HERITAGE PRESERVATION BOARD JUNE 7, 2021, AT 6:30 PM CITY HALL AUDITORIUM 324 EAST PINE STREET, TARPON SPRINGS, FLORIDA

GAIL KIDWELL APPLICATION #21-61

NOMIKI VAVLAS APPLICATION #21-60

Application No. / Project Title:	21-60 / Nomiki Vavlas
Staff:	Patricia L. McNeese, AICP Principal Planner
Applicant / Owner:	Bokova Industrial Center / Nomiki Vavlas
Property Size:	4,000 square feet (building)
Current Zoning:	T5b (Tarpon Ave Main Street)
Current Land Use:	Community Redevelopment District
Location / Parcel ID:	101 & 105 East Tarpon Avenue / 12-27-15-64998-000-0031
Architectural Type/District Status:	masonry vernacular/contributing

New dark bronze aluminum hurricane impact store front Window and door system glazed with clear 9/16 impact Laminated glass. There is one pair of 3-0 x 7-0 doors with a transom and comes with Mtg. standard Door hardware package. Approx. size from 20-0 x 10-0.

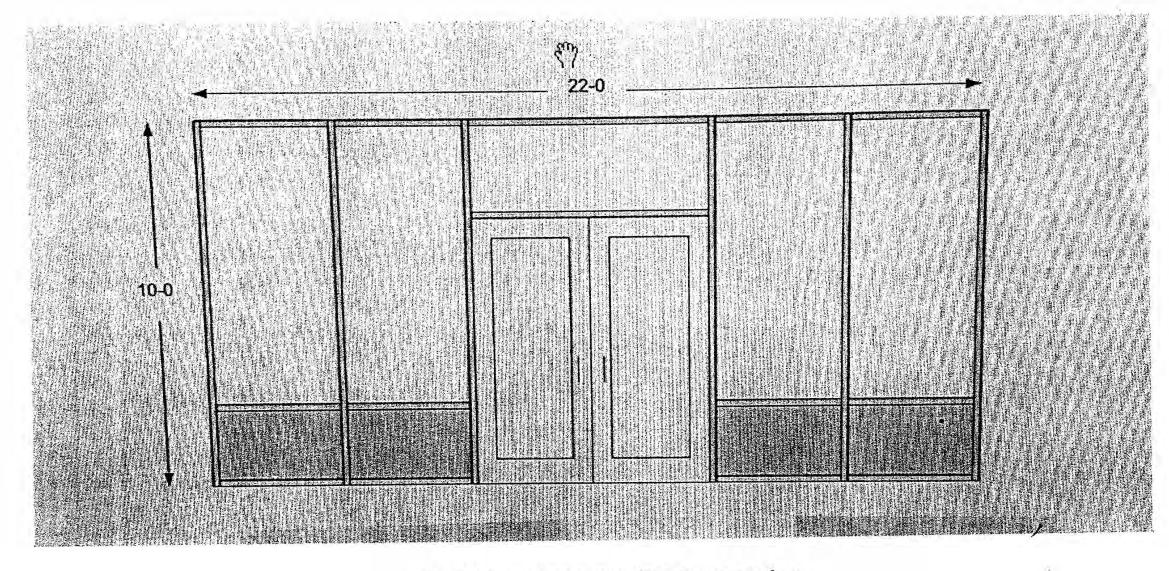
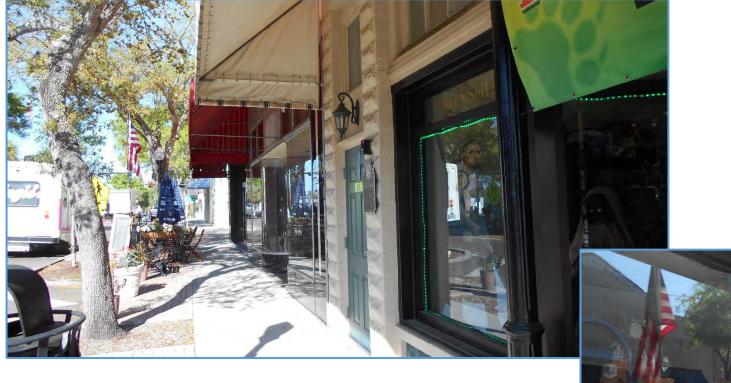
The applicant is seeking a Certificate of Approval (CA) to completely replace the existing storefront at 105 East Tarpon Avenue with a storefront that matches the existing one at 101 East Tarpon Avenue on the same property. The storefront replacement will include replacement of the black tile (vitrolite) material with brick veneer. The applicant has already received a Certificate of Approval for replacement of the vitrolite at 101 East Tarpon Avenue with brick veneer (CA #21-29 approved by the Heritage Preservation Board on April 5, 2021).

ANALYSIS: The applicant is proposing replacement of the existing recessed entry, windows, and door with a single plane storefront entry matching the adjacent store to the west, thereby enclosing the recessed area. The applicant has not presented any historical documentation for this building. The FMSF form notes the following alterations on the building, circa 1940: storefronts replaced, vitrolite panels added, exterior stuccoed (date unknown). The form also lists the "angled storefront entry" [sic] on the east unit (105 East Tarpon Avenue) as a notable architectural feature. This feature is considered to be original in form and important to the architecture and historical context of this building.

ANALYSIS: The most significant historical changes to this property as noted on the FMSF form were the replaced storefronts and the vitrolite panel additions (circa 1940). Staff could not locate any historical photographic documentation of the subject storefront (105 East Tarpon Avenue). Although historical documentation is lacking, it is very possible that the change to the subject storefront might have included the metal elements (fixed transom windows and storefront door) and the curved display windows, in addition to the exterior vitrolite building fabric. With respect to these elements, the curved display windows are probably the most outstanding features resulting from past (historical)

alterations and are considered to have acquired significance in their own right since they convey particular tastes of the time (1930s – 1940s era). Replacement of these windows with something documented to be closer to the original 1890s condition might be considered for discussion, but that is not what is being proposed here. Therefore, the removal of this change as part of the history and development this property is not appropriate.

The vitrolite panels were most popularly used with Art Moderne and Art Deco architecture. Again, the change may have coincided with the installation of the curved windows and metal doors/windows. However, a brick building fabric is more congruent with the building's original 1890s-era construction since the brick is visible on the inside of the building both in the walls and in the display window support panel. Therefore, it is acceptable to replace the vitrolite with the brick veneer as this change will take the building closer to its original facade.
